PM7364 FREEDM-32

REVISION D AND E DEVICE ERRATA

Issue 6: November, 2001

Figure 2.1: Receive Packet Descriptor.

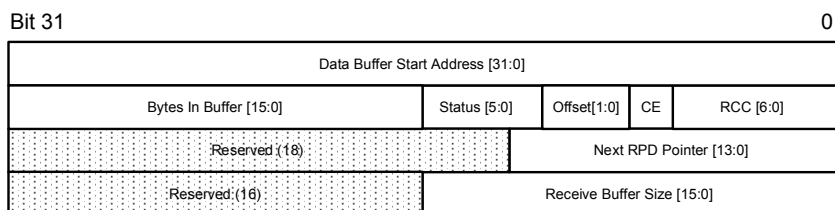
2.1. Offset underflow in Receive Packet Descriptor

When ALL of the following conditions are met:

1. The offset[1:0] field of a Receive Packet Descriptor (RPD) is non-zero.
2. The STRIP bit of register "**0x204 RHD L Indirect Channel Data Register #1**" is logic one.
3. The incoming packet payload is smaller than the FCS field (2 bytes for CRC-CCITT or 4 bytes for CRC-32).

The value in the "Bytes in Buffer [15:0]" field of the RPD can be underflowed. That is, this field will contain a negative value. If this field is interpreted as an unsigned integer, the content of the buffer can be erroneously interpreted as a very large number.

1. If the Offset[1:0] bits of RPD are set to zero, this problem will not occur.
2. If the STRIP field of "**0x204 RHD L Indirect Channel Data Register #1**" is set to zero, this problem will not occur.
3. If the buffer size is not larger than 32K Bytes, the most significant bit of the "Byte in Buffer" field can be used as a sign bit. The device software should discard RPDs that contain a negative "Bytes in Buffer" value.
4. For every RPD, the driver software can compare the "Bytes in Buffer[15:0]" field to ensure that it is smaller than or equal to "Receive Buffer Size[15:0]".

Figure 2.2: PCI Interface Timing

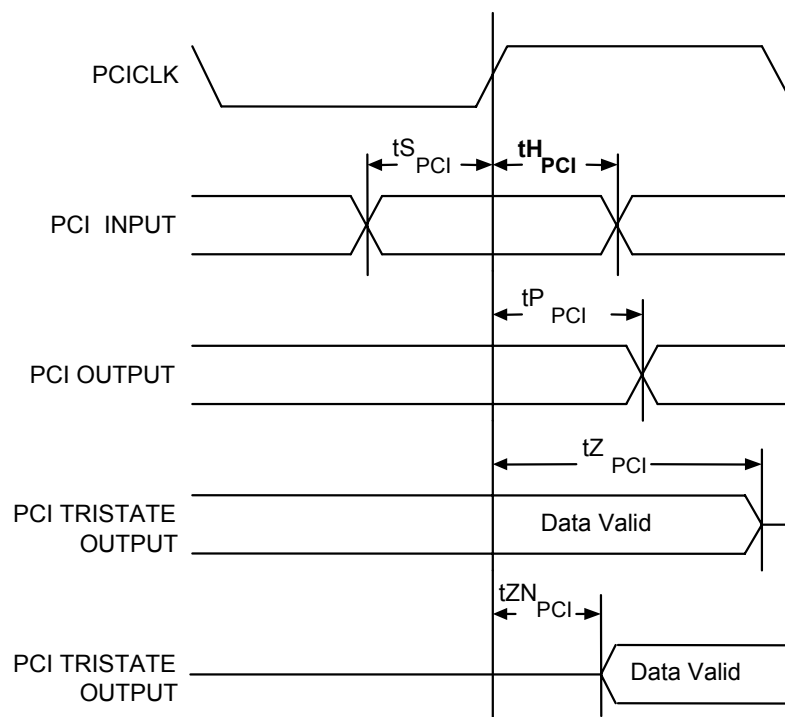
2.3. PCI Hold Time Increased to 1ns.

PCI Input and Bi-directional signals require a minimum hold time ($t_{H_{PCI}}$) of 1 ns with respect to PCICLK.

The PCI 2.1 specification requires PCI outputs to have a minimum 2 ns propagation delay. The clock skew between FREEDM-32 and other PCI devices in a system must therefore be kept below 1 ns to ensure correct operation.

Figure 3.1: Receive Packet Descriptor.

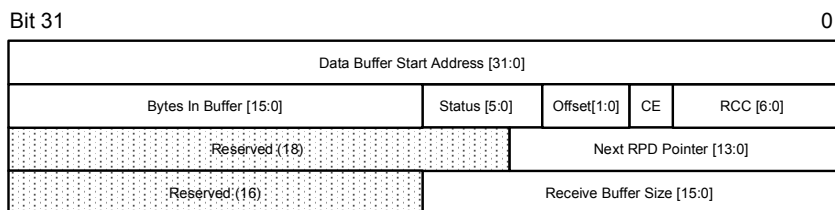
3.1. Receive Packet Descriptor, Buffer Size Restriction

The Receive Buffer Size [15:0] field of the RPD was incorrectly specified in the FREEDM-32 Datasheet.

In Table 6 "Receive Packet Descriptor Fields" of, Receive Buffer Size [15:0] is currently specified as:

Field	Description
Receive Buffer Size [15:0]	The Receive Buffer Size [15:0] bits indicate the size in bytes of the current RPD's data buffer. This field is expected to be configured by the Host during initialization. <u>The Receive Buffer Size must be a non-zero integer multiple of four and less than or equal to 32764.</u> The Receive Buffer Size is valid in all RPDs.

The correct description of Receive Buffer Size [15:0] is shown below.

Field	Description
Receive Buffer Size [15:0]	The Receive Buffer Size [15:0] bits indicate the size in bytes of the current RPD's data buffer. This field is expected to be configured by the Host during initialization. The Receive Buffer Size must be a non-zero integer multiple of four and less than or equal to 32764. <u>The Receive Buffer Size must be a non-zero integer multiple of 16 and less than or equal to 32752.</u> The Receive Buffer Size is valid in all RPDs.
